**To:** Richard Collier, McKim & Creed  
**From:** Brian Chambers, Senior Planner; 910.342.2782  
**CC:** File;  
**Date:** 4/27/2021  
**Re:** RiverLights Conventional Phase V & VI TRC Rev 2

**Riverlights Conventional Ph 5 & 6 Standard Street Lighting Plan**

**RIVERLIGHTS CONVENTIONAL PHASE 5 & 6**  
 MASONBORO TOWNSHIP, WILMINGTON, NEW HANOVER COUNTY, NORTH CAROLINA

**OVERALL SITE PLAN**

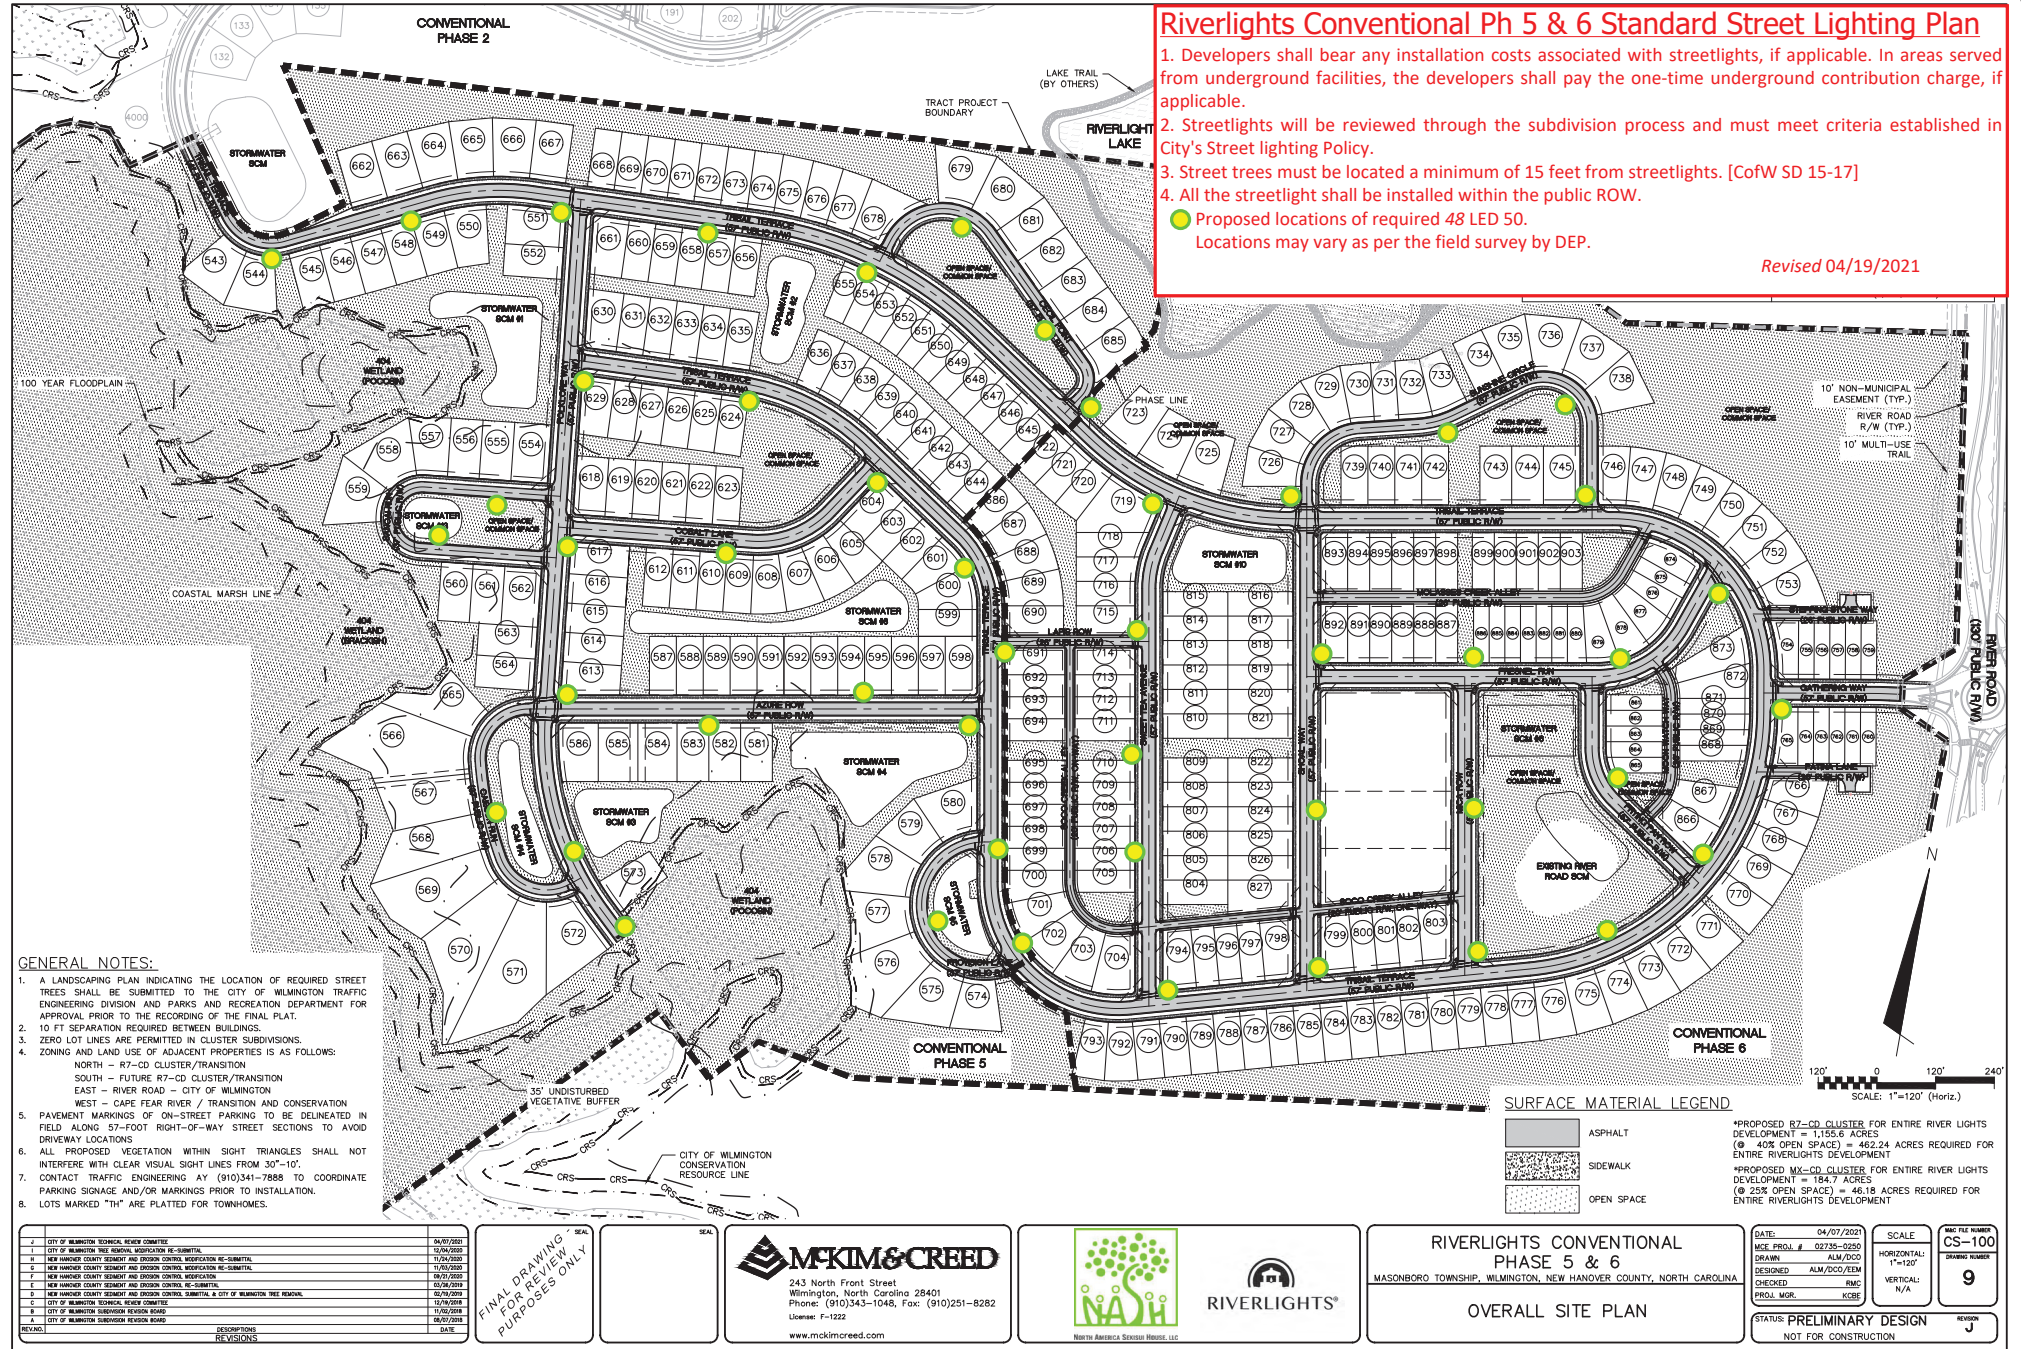
1. Show the existing/proposed streetlight at the conjunction of phase 5 with phase 2 on Trisail Terrace. Show this on existing and proposed overall site plan sheet.

3. A revised layout for the Standard street lighting has been provided with this review. Minimum of 48 (forty-eight) LED 50 streetlights are required for this sub-division. Although, developers may choose to provide any extra lights or ornamental. Any installations above the criteria of Standard street lighting, will be considered as non-standard and must conform to the City's non-standard street lighting procedure as per the policy.

1. Developers shall bear any installation costs associated with streetlights, if applicable. In areas served from underground facilities, the developers shall pay the one-time underground contribution charge, if applicable.
2. Streetlights will be reviewed through the subdivision process and must meet criteria established in City's Street Lighting Policy.
3. Street trees must be located a minimum of 15 feet from streetlights. [CofW SD 15-17]
4. All the streetlight shall be installed within the public ROW.
  - Proposed locations of required 48 LED 50.
  - Locations may vary as per the field survey by DEP.
